**New Albany Architectural Review Board Meeting**  
**Amended Agenda** Monday, February 09, 2026, 7:00 p.m.

**ZC-80-2025 Fire Station COA**

Certificate of Appropriateness to allow for a proposed fire station on 6.350+- acres of land generally located at the northwest intersection of State Route 605 and New Albany Road East (Parcel ID: portion of 222-005258).

**Applicant: Schorr Architects c/o Nathan Gammella**  
**Presented by Sierra Saumenig**

# Proposed Addition Parking Lot Pointed directly at Residences WITHOUT Screening

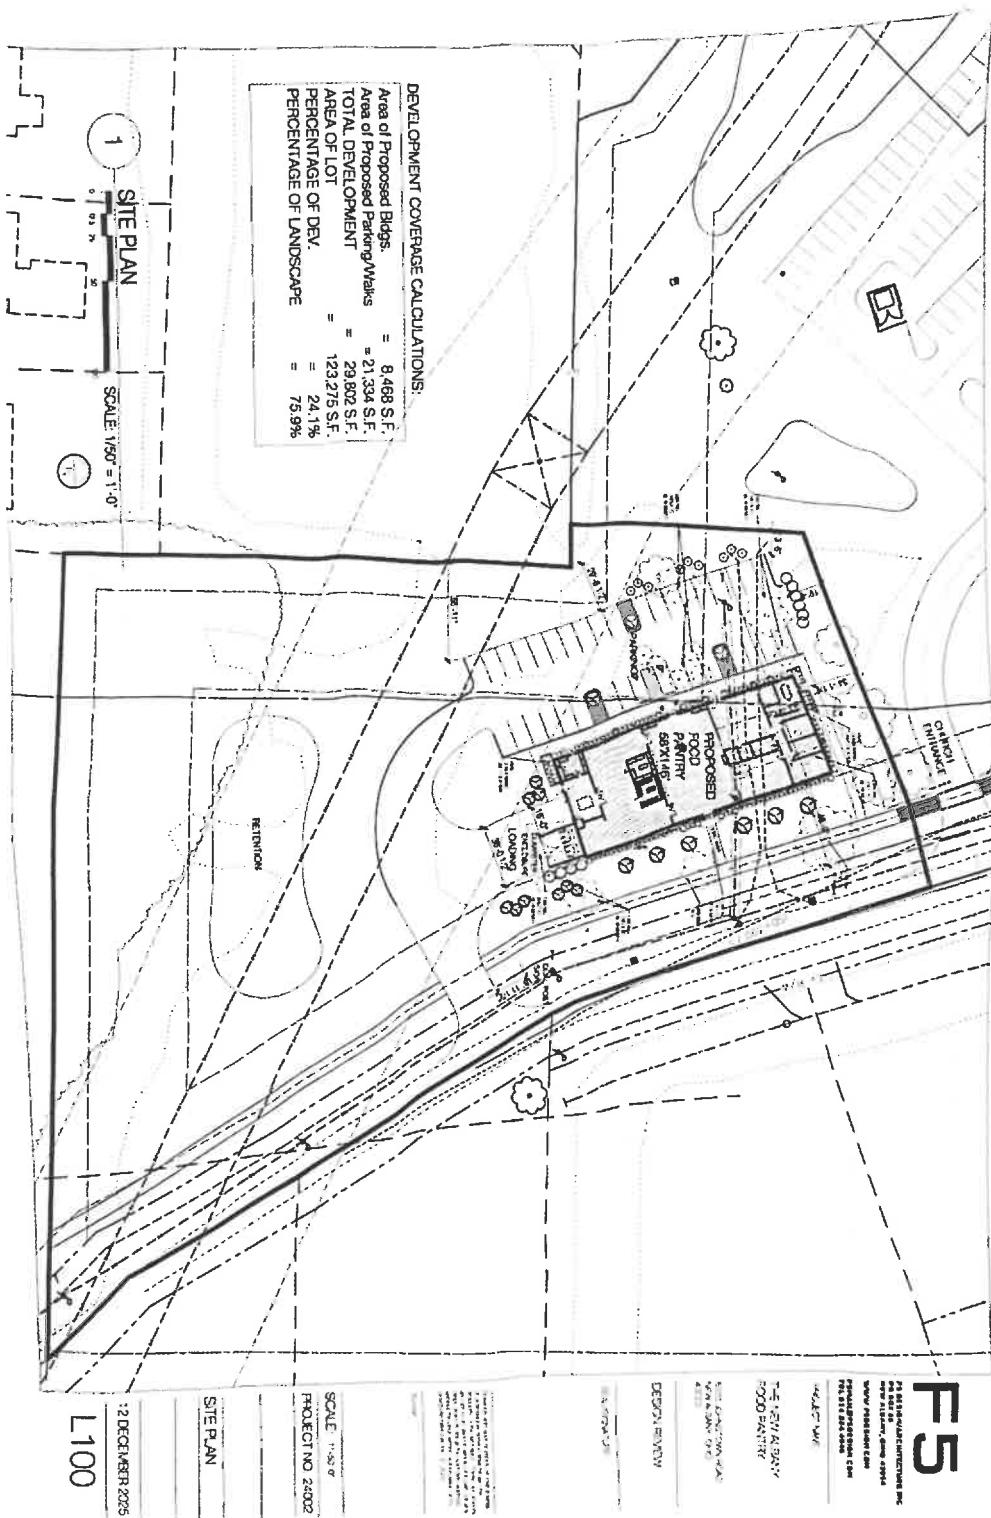
- Required headlight screening (C.O. 1171.06(b)) is not provided
- Screening was a **documented commitment** in 2011 ARB + PC approvals + Zoning Text
- Applicant has a **history of non-compliance** with existing zoning conditions
- Proposed design **cannot meet code** due to AEP easement constraints
- Zero screening would directly impact **homes and James River Park**
- Neighbors need long term guarantees that screening will be in place and maintained by property owner for years to come

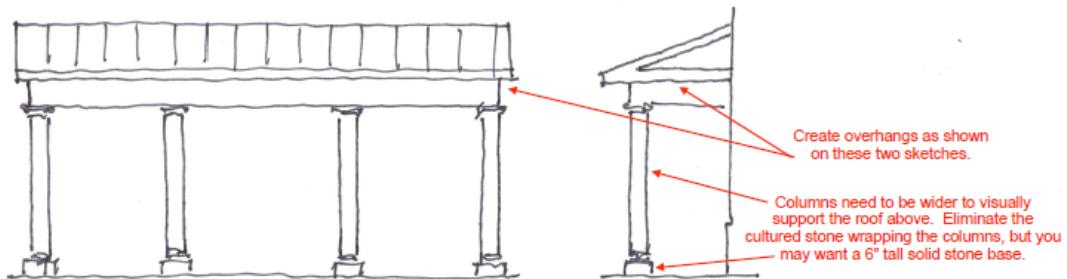
- The two-story gable at the main entry appears inconsistent with the overall front façade. The City Architect recommends removing the gable and redistributing the windows to achieve a more balanced and cohesive design. If the gable is retained, a centered second-story window will be required, as illustrated below.

- Provide a taller roof pitch on cupola.

- Create overhangs as shown on the sketch below
- Columns should be wider to visually support the roof above. Eliminate cultured stone wrapping the columns and use a 6' tall solid stone base.
- Align neck of columns.
